From: Yee, Chung K. (ECY) [mailto:cyee461@ECY.WA.GOV]
Sent: Tuesday, March 10, 2015 9:37 AM
To: Bottcher, Helen; Scheffler, Ken/SEA; McKinley, Scott/CVO
Subject: Ecology's comments on the upper aquifer groundwater result report

Figure 8 | Aqueous phase concentrations immediately downstream of DNAPL source

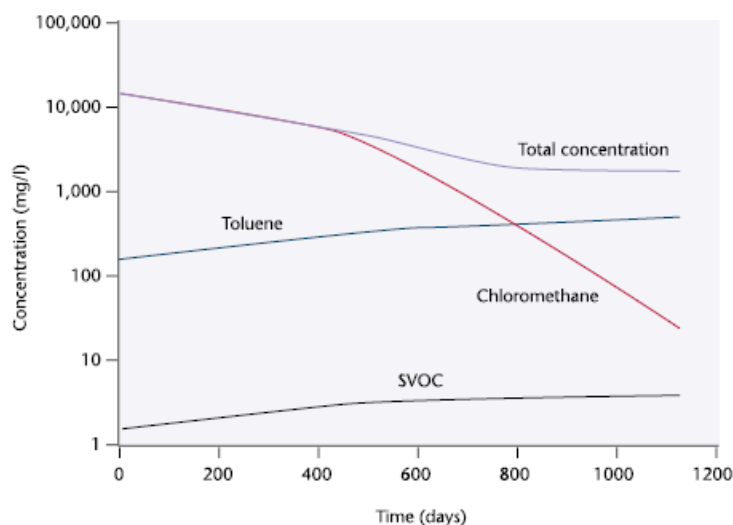
Comment 10. Section 6.1: “Other PAH constituents present in the NAPL would also partition to groundwater . . . Their rate of partitioning would increase over time as their mole fraction increases in response to loss of naphthalene mass.”

If the higher molecular weight PAHs are more refractory to microdegradation, the rate of partitioning might be microdegradation rate limited. As written, the above gives me the impression that degradation rate would be increasing over time. Is that the correct interpretation?

Response. No. This discussion focuses on the partitioning of PAH constituents from the NAPL to groundwater over time. As the mass of constituents with higher aqueous solubility's decreases the dissolved phase concentration of the constituents with lower aqueous solubility's increases. In the example below, as the mass of chloromethane (which has the highest solubility) decreases, the predicted concentration of the remaining constituents increases. Other aquifer physical/chemical/biological conditions often result in observed conditions that differ from theoretical.
